Addendum #4

Date: June 5, 2024

Project Name APMT Phase IV Yard Expansion

Project # 11261

SUBSTATION 4 PARTIAL ONE LINE DIAGRAM

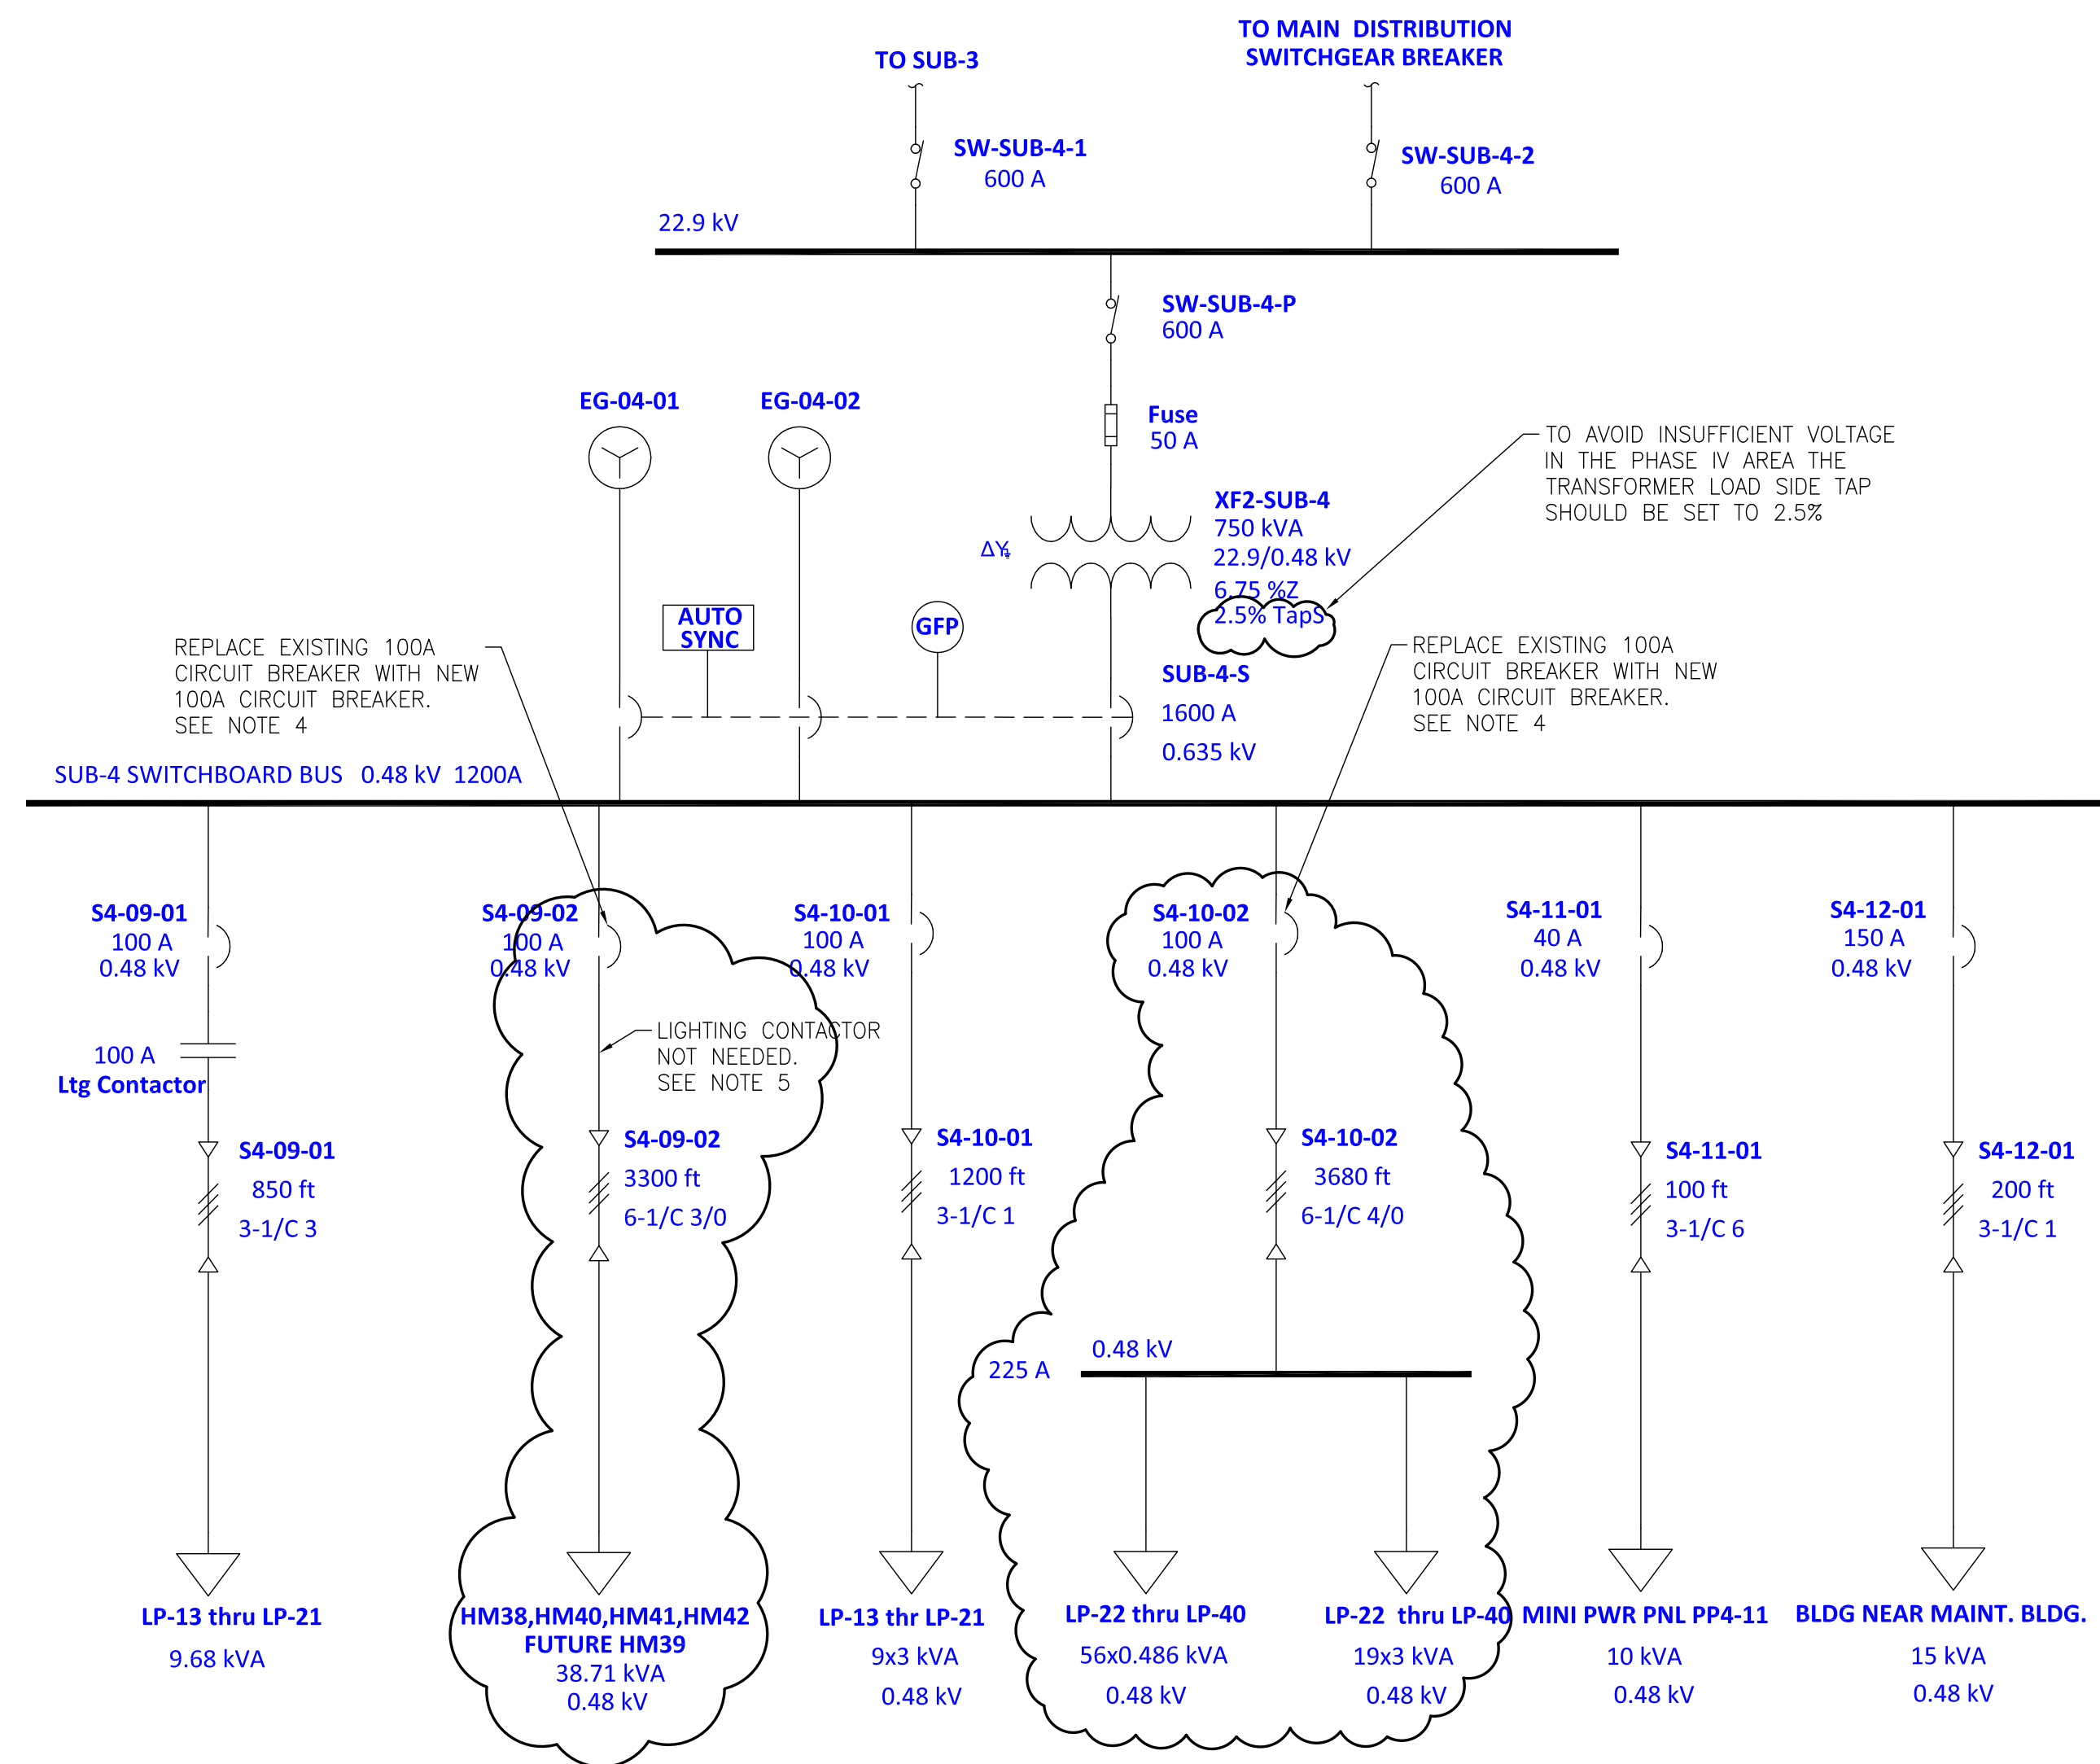
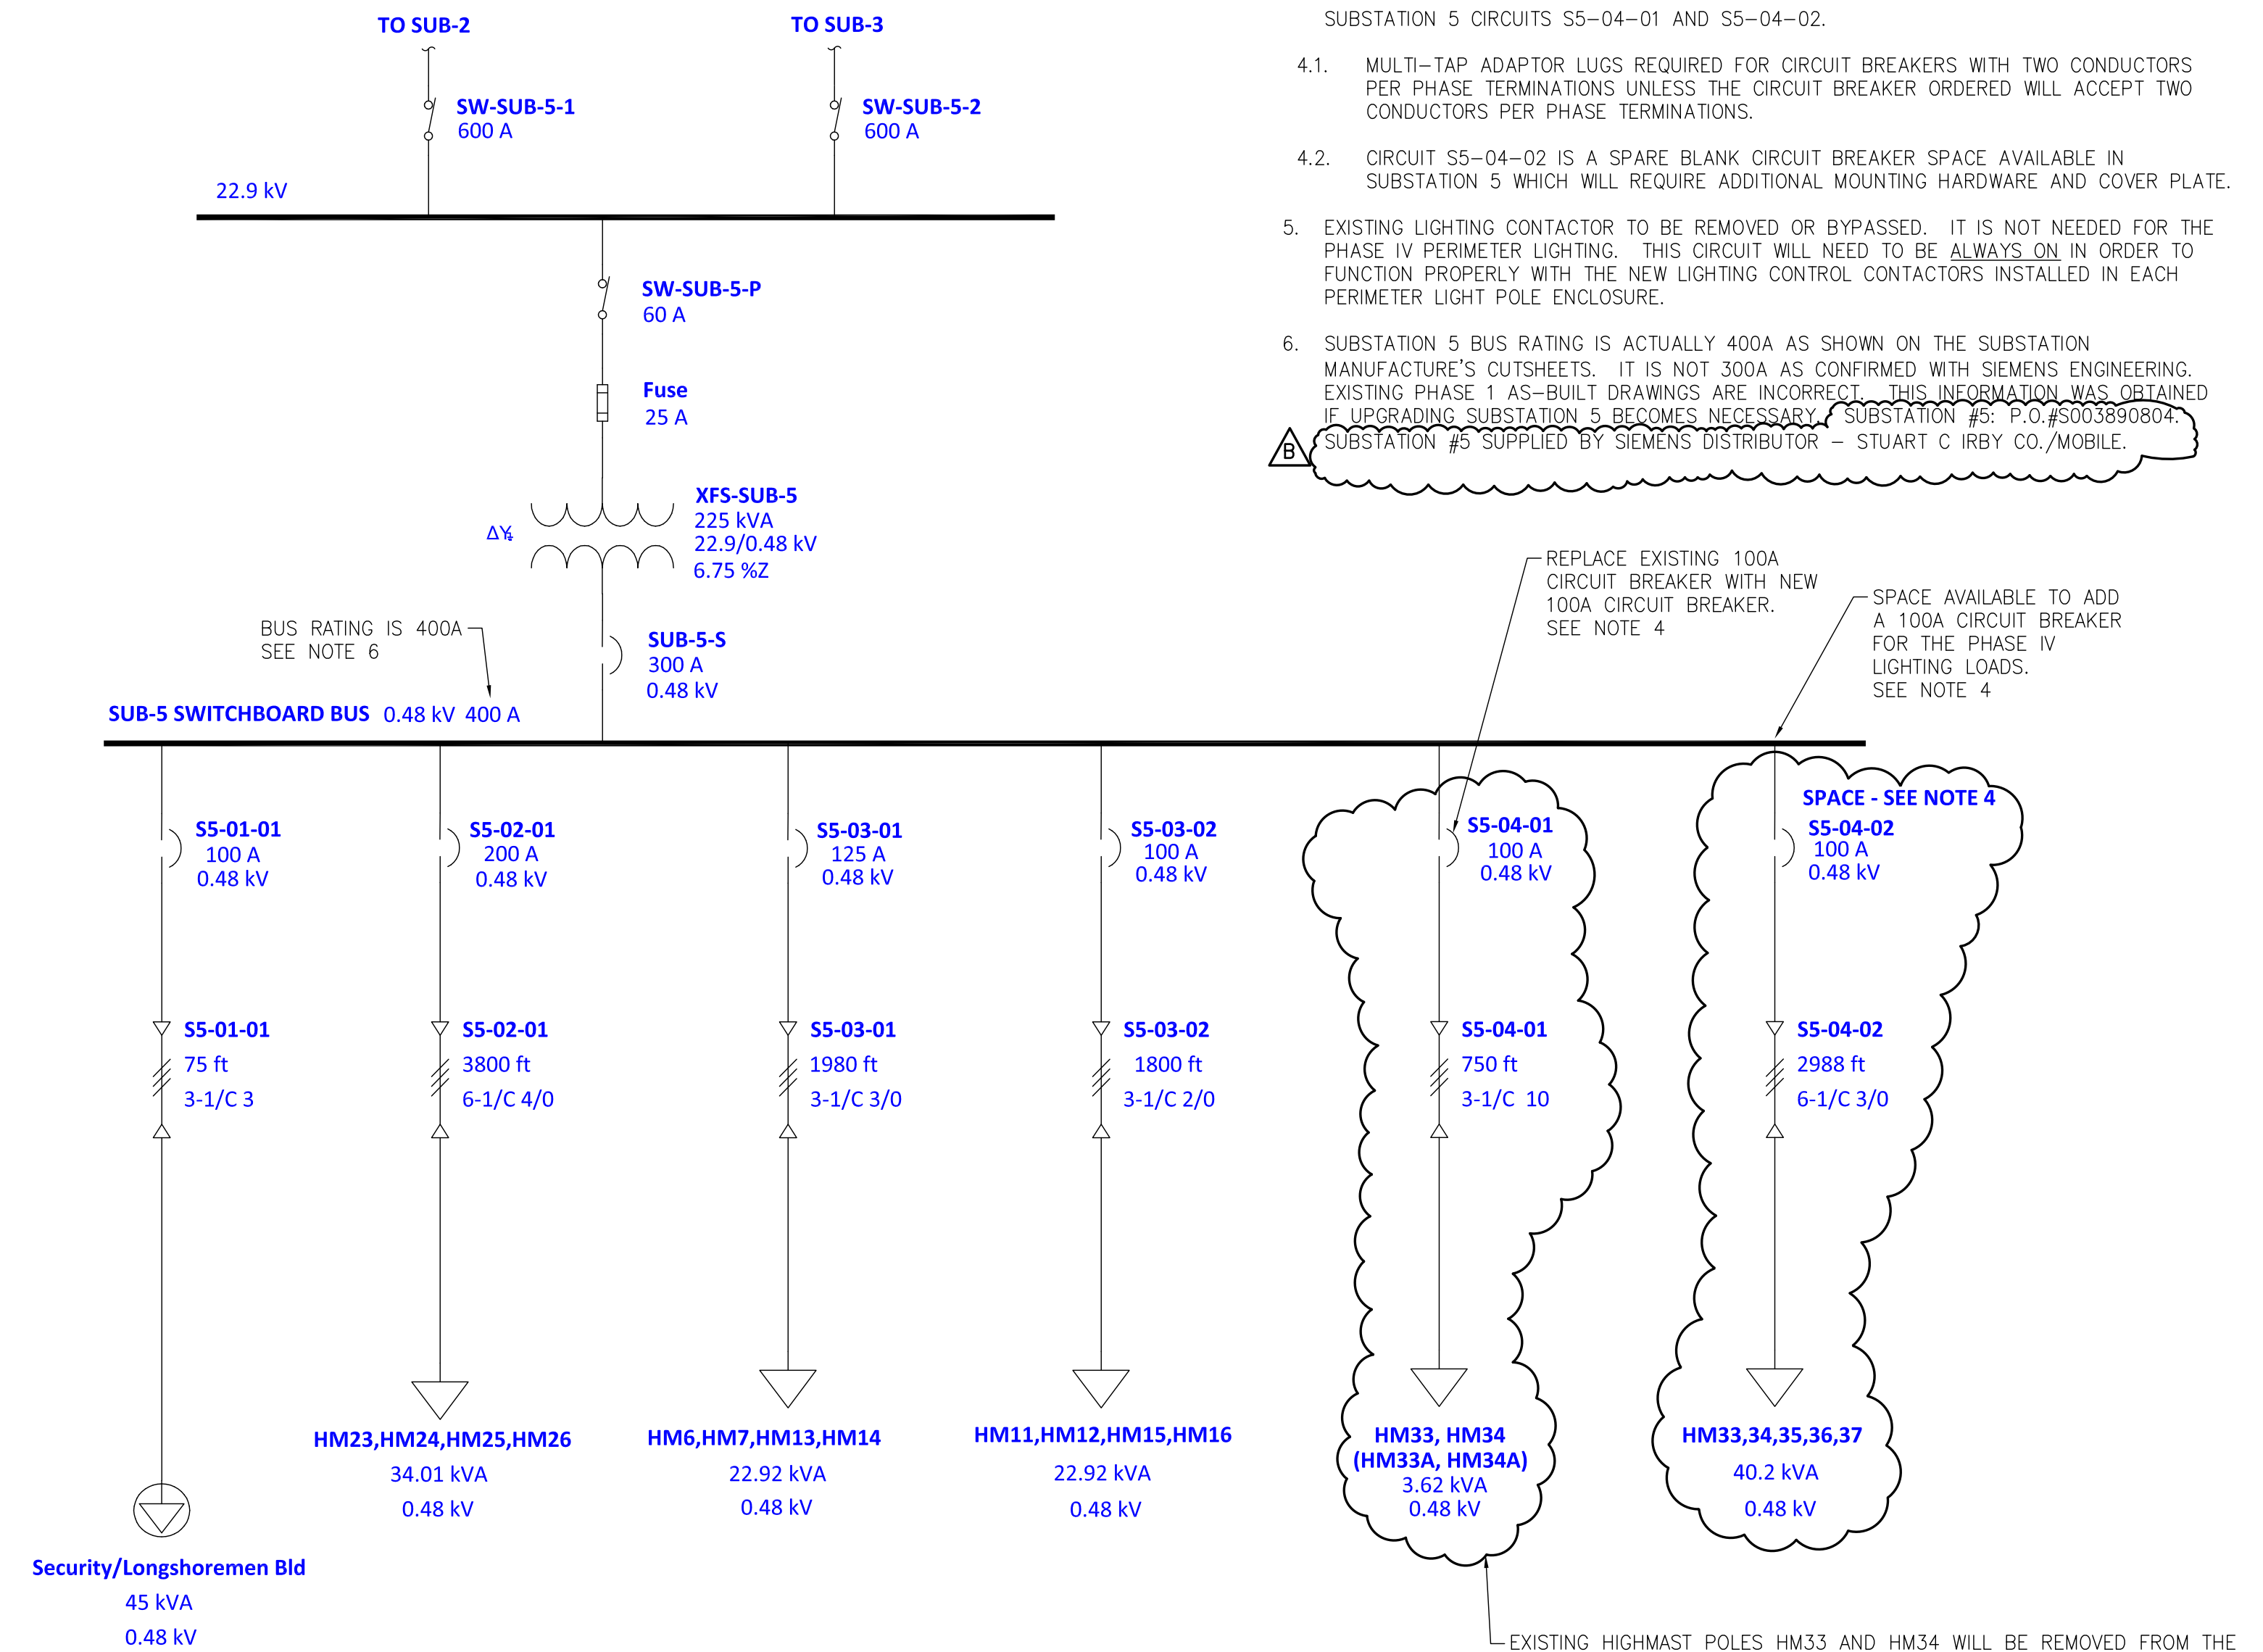
B	REVISED FOR BID - NOTES 4 AND 6	WMB	MED	RSG	06/05/24
A	ISSUED FOR BID	WMB	MED	RSG	04/05/24

- CLOUDED AREA ON DRAWING REPRESENTS THE ELECTRICAL SCOPE OF WORK.
- CONFIRMED WITH SWITCHGEAR MANUFACTURE THAT THERE IS A SPACE AVAILABLE IN THE SUBSTATION 5 SWITCHBOARD TO ADD ONE ADDITIONAL 100A CIRCUIT BREAKER IN THE FUTURE.

- SUBSTATION 5 BUS RATING IS ACTUALLY 400A AS SHOWN ON THE SUBSTATION MANUFACTURE'S CUTSHEETS. IT IS NOT 300A AS CONFIRMED WITH SIEMENS ENGINEERING. EXISTING PHASE 1 AS-BUILT DRAWINGS ARE INCORRECT. THIS INFORMATION WAS OBTAINED IF UPGRADING SUBSTATION 5 BECOMES NECESSARY. SUBSTATION #5: P.O.#5003890804. SUBSTATION #5 SUPPLIED BY SIEMENS DISTRIBUTOR - STUART C IRBY CO./MOBILE.
